Follow up comments from Philly Bike Action post-CCRA/FNSA Meeting

Bike Lane Separators on Walnut St

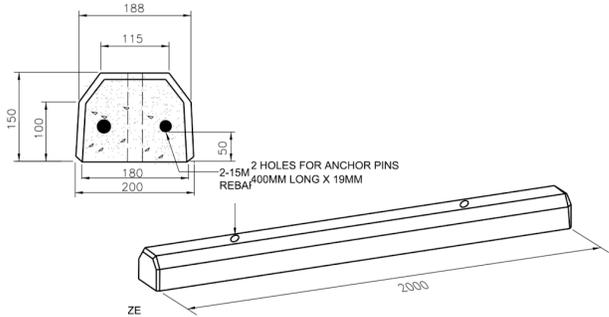
We're very glad to hear that these separators will be concrete. However, separators should be closely spaced close for maximum protection.

- Gaps wide enough for a car to enter will allow cars to block the bike lane, which will pose extreme risk to cyclists who will have to merge into the turning lane to avoid obstacles.
- Concrete separators will also provide protection for cyclists when no cars are parked.
